# Groundwater Transfer Review Summary Form

Transfer/PA # T- 14421

Application: T-14421

1. Basic description of the changes proposed in this transfer: Applicant proposes to change the POAs under Permit G-18291 from the authorized POAs, POA 1 /Well 1 (PROP 554) and POA 2/Well 2 (PROP 555), to the proposed POAs, POA 3/Well 3 (LANE 73787) and POA 4/Well 4 (LANE 52059/12757). Permit G-18291 is authorized for nursery use on 30.0 acres at a maximum rate of 0.32 cfs and maximum annual duty of 150 AF.

**Map**

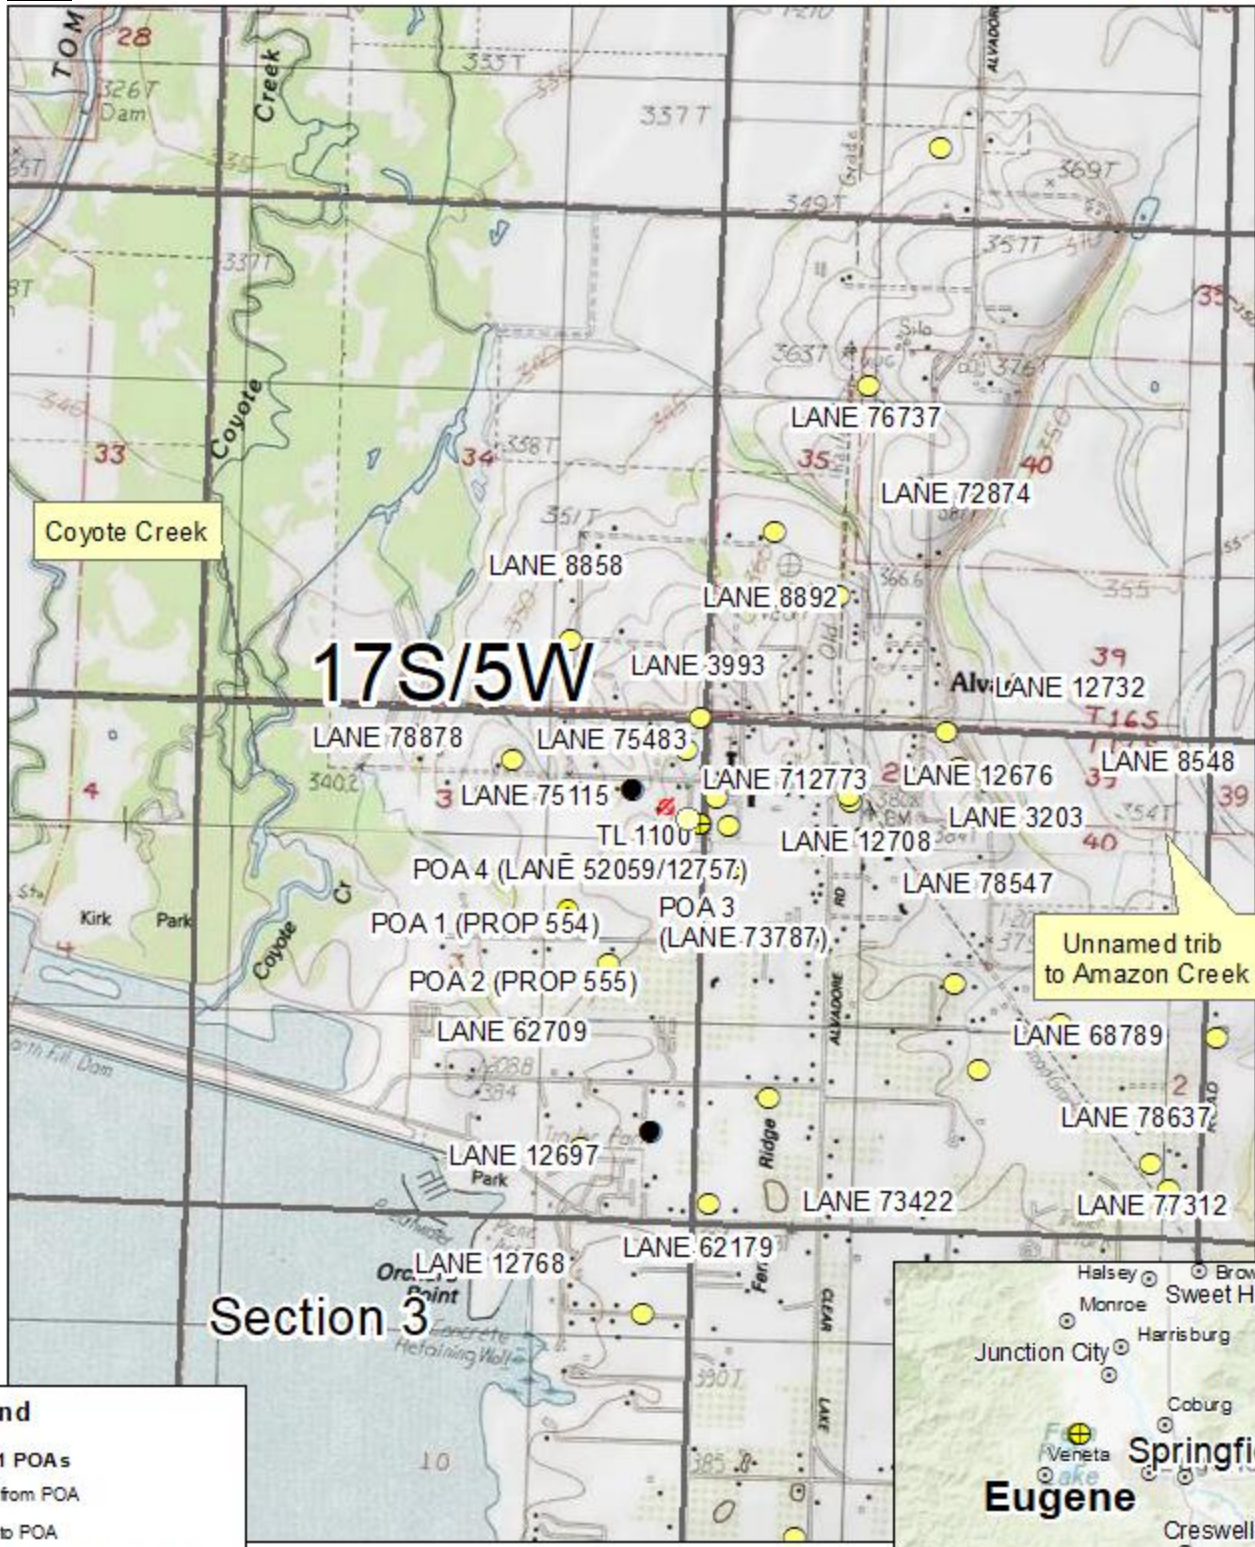
Yes  No Comments: The to-POAs (LANE 73787 and LANE 52059/12757) are closer to neighboring tax lot 1100 at 27266 8th St, which is presumed to be served by an exempt domestic well ("Tax Lot 110 Well"). The closer proximity of this domestic well will likely increase interference.

Yes  No Comments: The to-POAs (LANE 73787 and LANE 52059/12757) are closer to an unnamed tributary to Amazon Creek.

Provide context for minimal/significant impact: Although the to-POAs (LANE 73787 and LANE 52059/12757) are closer to an unnamed tributary to Amazon Creek, both to-POAs are further from the unnamed tributary to Amazon Creek than the from-POAs (PROP 554 and PROP 555) are from Coyote Creek. Both the surface water sources are within the same WAB (LONG TOM R WILLAMETTE R-AB MOUTH), so there is overall a decreased degree of interference anticipated with surface water.

**Theis Interference Analysis**

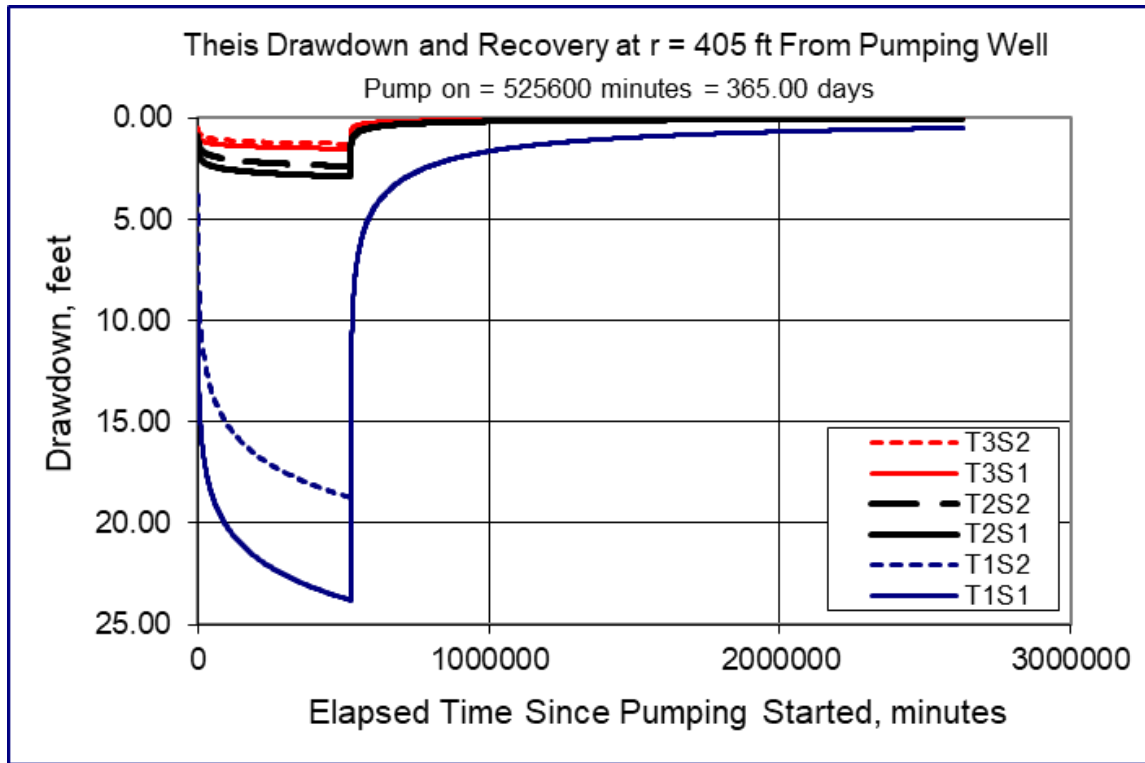
Yes  No If yes, explain: To-POA 4 (LANE 52059/12757) is 405 ft SE of the presumed location of the Tax Lot 1100 Well. The Theis (1935) solution was used to assess interference from proposed to-POA 4 (LANE 52059/12757) at the presumed location of the Tax Lot 1100 Well (see attached Theis Interference Analysis). Results indicate that the proposed change is unlikely to injure the Tax Lot 1100 Well. To-POA 3 (LANE 73787) is further from the presumed location of Tax Lot 1100 Well, and would result in even less drawdown and is therefore unlikely to injure the Tax Lot 1100 Well.
